< PL5161 Change Section >

1. RX Part : IF IC change

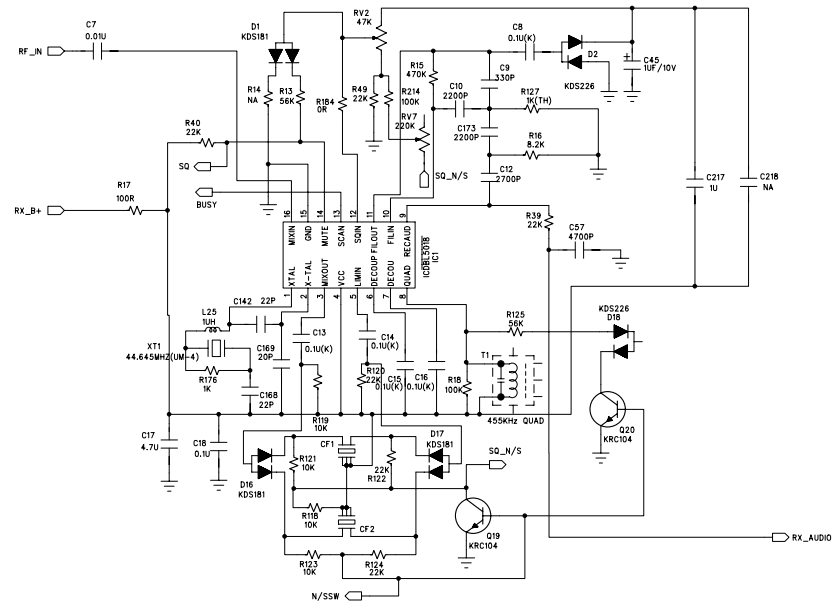
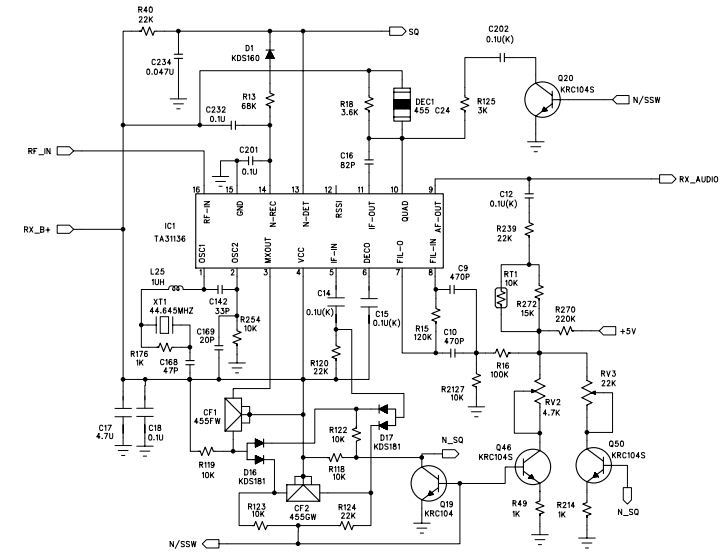
==> Before (DBL5018 / SL5018)

==> After (TA31136)

2. PLL and VCO Part

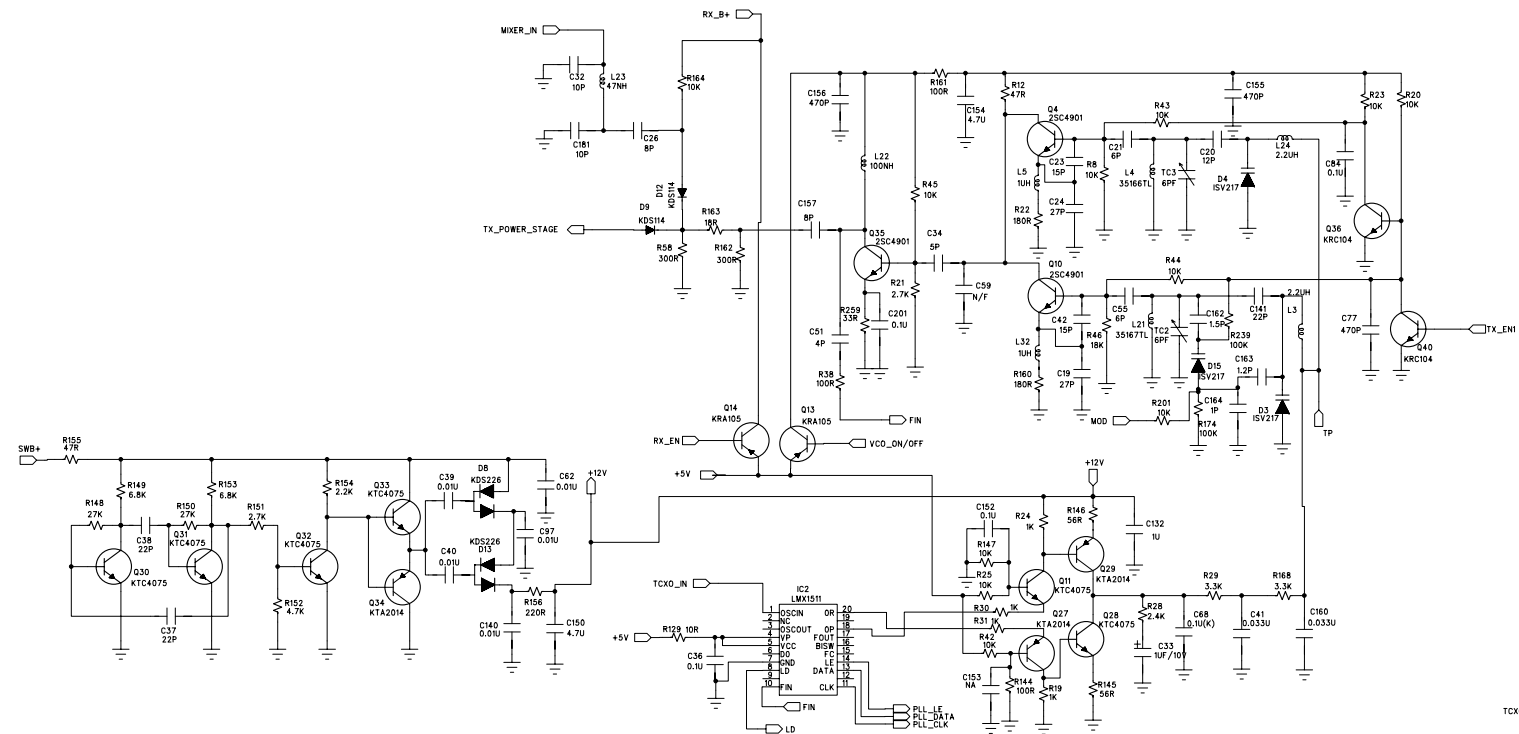
==> Before (PLLIC :LMX1511)

==> After

- . DC to DC Convertor :Delete
- . Charge pump : delete
- . PLL IC : LMX2316
- . VCO : Circuit Change
